# Access Compliance Report

## Public Rights-of-Way

Intersection ID: 22127	Main Street: OLD_PROVIDENCE_RD	Cross Street: RIVER_OAKS_LN	Location: SW
ADA ID: 11FA7B5F1465	Ramp Type: PerpDiag	Initial Pass/Fail: Fail	Overall Compliance: No
Severity Score: 85			
Codes/Mitigation Info/Possible Solution		Field Measurements/Component Compliance

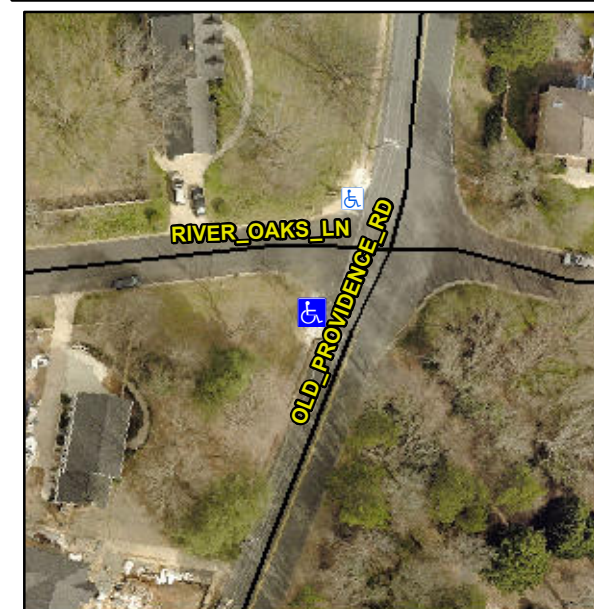
**Not Found, R304.5.1, R304.2.2, R304.5.3**

Compliance	Description	Data	Compliance	Description	Data
N/A	Ramp Length (in)	63.0	No	Ramp Slope (%)	13.2
No	Ramp Width (in)	30.5	No	Ramp XSlope (%)	7.9
N/A	Flare Type LT	N/A	N/A	Flare Type RT	N/A
N/A	Flare Slope LT (%)	N/A	N/A	Flare Slope RT (%)	N/A
N/A	Flare Traversable LT?	N/A	N/A	Flare Traversable RT?	N/A
N/A	Landing Length (in)	N/A	N/A	DWS Provided?	N/A
N/A	Landing Width (in)	N/A	N/A	DWS Contrast?	N/A
N/A	Landing Slope (%)	N/A	N/A	DWS Length (in)	N/A
N/A	Landing X Slope (%)	N/A	N/A	DWS Full Width?	N/A
N/A	Landing Curb? (Y/N)	N/A	N/A	DWS Offset (in)	N/A
N/A	Shared Landing?	N/A			
N/A	Gutter Ponding?	N/A	N/A	Gutter Slope (%)	N/A
N/A	Gutter Lip Ht (in)	N/A	N/A	Gutter X Slope (%)	N/A
N/A	Painted X Walk1?	No	N/A	Painted X Walk2?	No
	X Walk 1 Direction	To E		X Walk 2 Direction	To NE
N/A	X Walk 1 Width (in)	N/A	N/A	X Walk 2 Width (in)	N/A
	X Walk 1 Slope (%)	2.6		X Walk 2 Slope (%)	3.4
	X Walk 1 X Slope (%)	2.5		X Walk 2 X Slope (%)	1.7

**Remove & Replace Curb Ramp With Two New Directional Ramps or Equivalent.**
